IN THE DRAWINGS

REMARKS

FIG. 1A (RELATED ART)

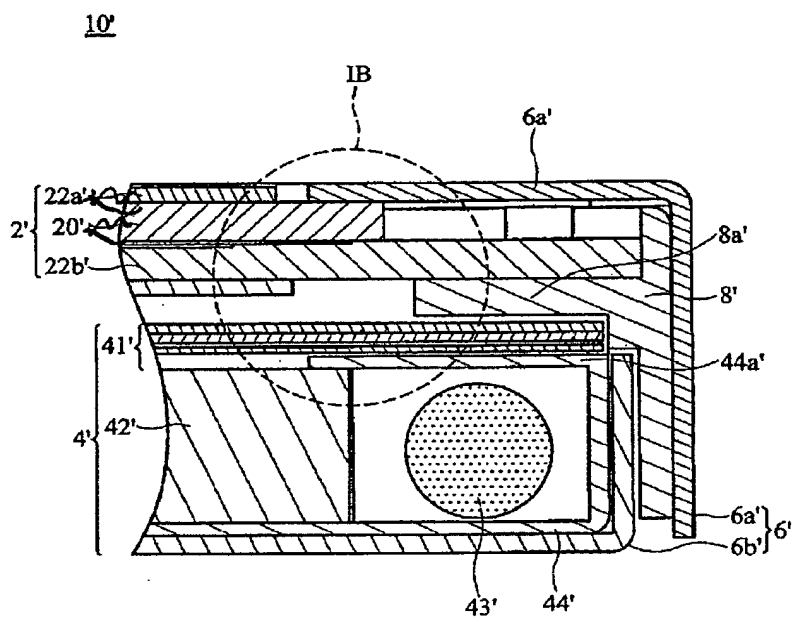
Please replace Figs. 1A, 2A, 2B, 3A and 3B with corrected drawings in the attached sheets. In these drawing sheets, minor changes have been made to lead line and reference designators, as shown in the annotated drawing sheets.

The drawings are corrected according to the description of the specification. Specifically, minor changes are made to lead lines and reference designators of the drawings, as illustrated in the accompanying annotated and replacement drawing sheets.
